Access Compliance Report Public Rights-of-Way (Curb Ramps)

Main Street: GREENWICH_LN Cross Street: BROADWAY Location: SW

ADA ID: RPRK220218210714 Ramp Type: Type 3 - Combination 1 Initial Pass/Fail: Fail Overall Compliance: No Severity Score: 5

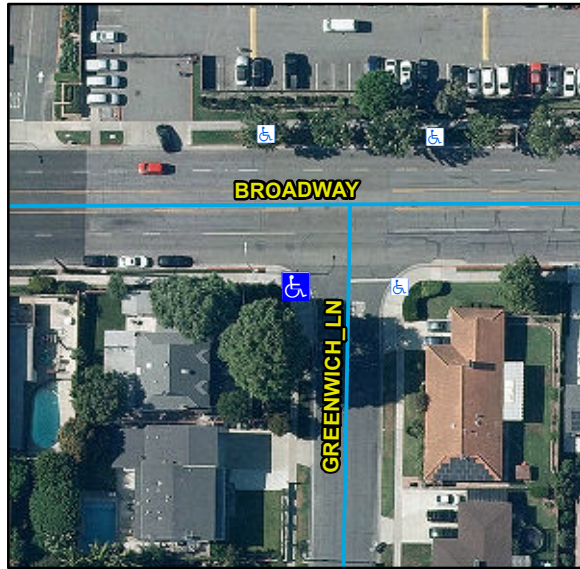
R304.5.1, R304.5.3, STD 1115

Remove & Replace Curb Ramp With Two New Directional Ramps or Equivalent. Remove & Replace Sidewalk.
